**Subject:** Dublin Port Berth 50 A extension and new turning circle  
**Attachments:** Comments\_DPC MP2\_dredge application.pdf; CM1095\_MA\_0168\_DWG\_03  
Dredging General Arrangement November 2018-0168 (3..\_dredge area.pdf)

**RE: Dublin Port Company Master Plan 2 – expansion to turning circles and extension to berth 50A.**

**Date: 23 May, 2019**

Purpose: DISCUSSION					
Title: CLIENT SCOPE CHANGE CLIENT REQUESTED MANEUVRING AREA					
Original Scale	Design/Draw	Checked	Authorised		
1:3500 @A1	TJOC	SMC	AC		
Date	Date	Date	Date		
01.11.18	01.11.18	01.11.18	01.11.18		
Status	Drawing Number	Rev			
I	CM1095_MA_0168_DWG	03

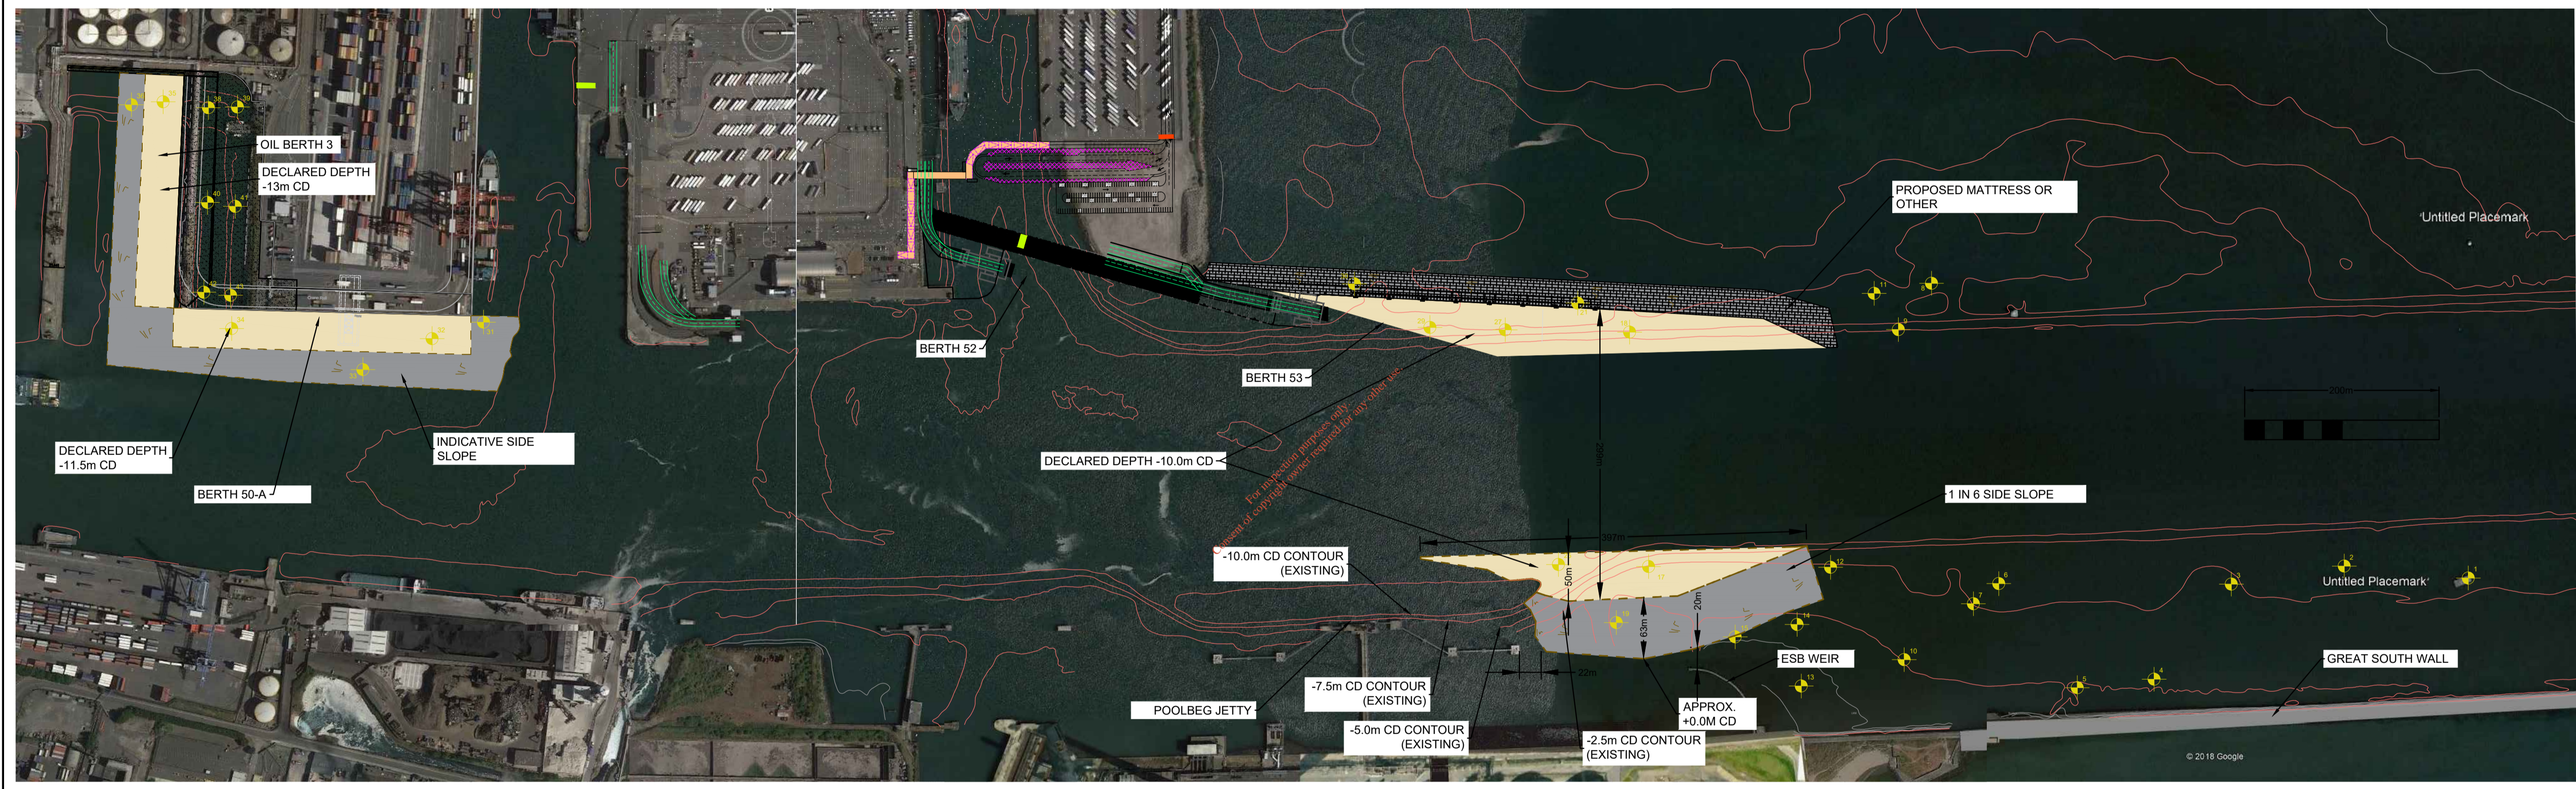
The sediment chemistry relates to approximately 125 000m<sup>3</sup> in the turning circle and 75 000m<sup>3</sup> in berth 50A only, and not to other areas in the port. Drawing number CM1095\_MA\_0168\_DWG indicates the location of the samples and the location of the dredging area and side-slopes.

Three samples from Oil Berth 3 demonstrate low class 2 concentrations of cadmium and one sample from the South Turning Circle shows low class 2 concentration of lead.

Three samples (two from Oil Berth 3, one from South Turning Circle) have concentrations of the sum of DDT metabolites slightly in excess of the Effects Range Low (ERL – an ecotoxicology risk standard often used), but these are well below the lower action levels of the three OSPAR Contracting Parties which have thresholds for DDT.

Samples taken from Oil Berth 4 had shown several contaminants at low class 2 levels but, in fact, Oil Berth 4 is an area to be infilled, rather than dredged.

The remaining samples are all below the lower Guidance Levels and therefore do not indicate any areas of particular concern.

In the absence of a feasible alternative, I would not object to the disposal of this sediment at the Burford Bank site.
